Global MX-5 Cup Car Technical Service Bulletin #03-01-2018 sections A & B

- A) Front bumper beam and 'form fitting' foam fill
- B) Shorter tow straps mounts

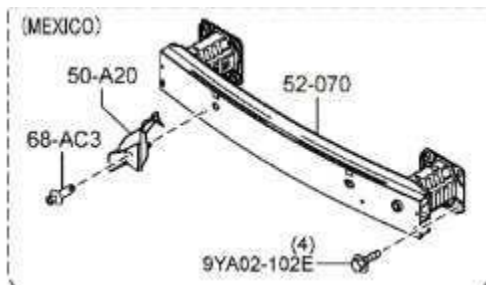
1. The original US spec front bumper beam may be replaced using the Mexico spec beam (Mazda part number N243-50-070D) and Japan spec foam insert (Mazda part number N243-50-111). These two parts must be used together as an "assembly". The foam insert is molded to better conform to the inner surface of the front fascia and may reduce fascia damage during bump drafting.
2. **NOTE: The air guide (see diagram below 50-A20) is required only if this TSB is NOT used**
